Walmart

GORDONSVILLE, VA
164 CAMPGREEN RD
STORE # 4162-03

REFRIGERATION PLANS

SHEET: R1

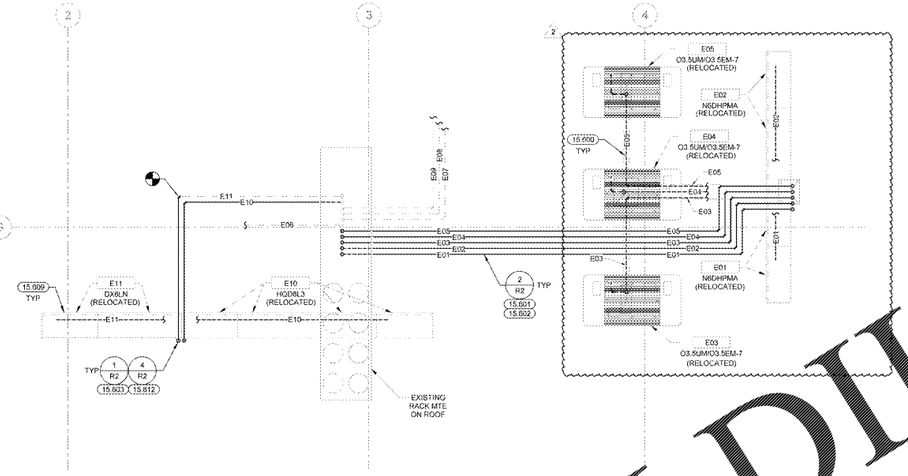
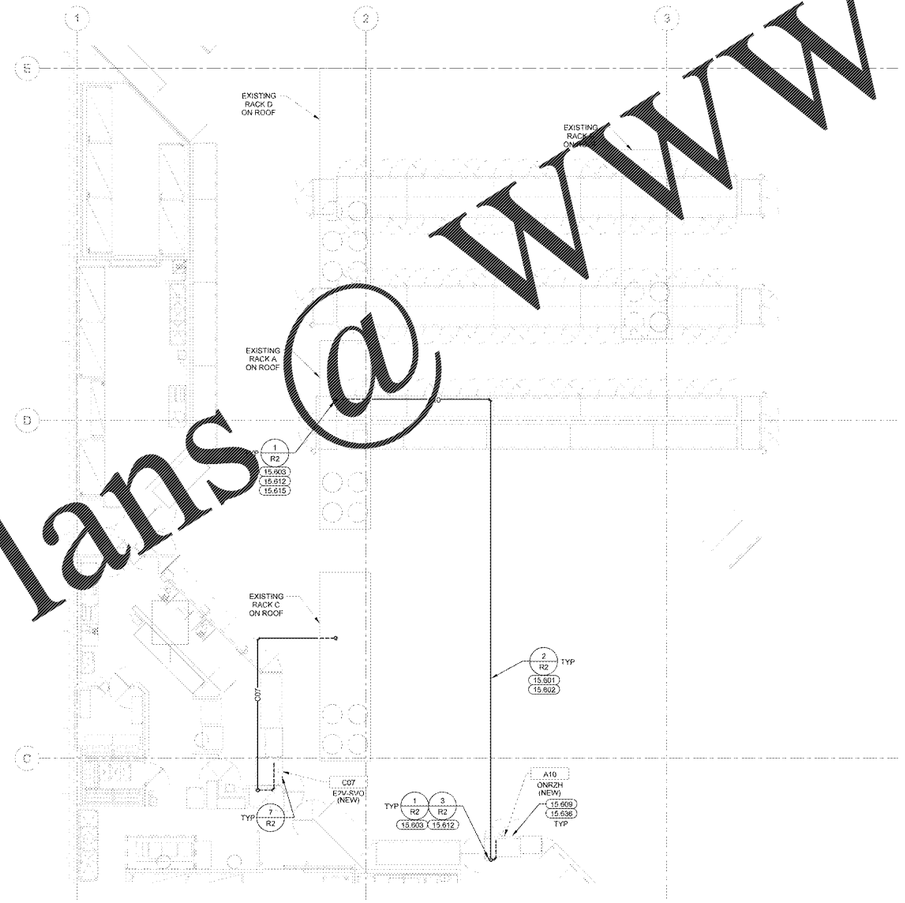
2 ADD KEYNOTE 15.609

2 REMOVE KEYNOTE 15.618

15.609	PROVIDE PVC DRAIN LINE FROM EACH CASE DRAIN CONNECTION SAME SIZE AS CASE OUTLET, AND END OVER FLOOR DRAIN W/AIR GAP. PITCH DRAINS 1" PER 10'.
15.612	PROVIDE INTERMEDIATE SUCTION LINE TRAP IN WALL OR VOID SPACE. INTERMEDIATE TRAP SHOULD BE PLACED AT THE MIDPOINT OF THE SUCTION LINE RISER.
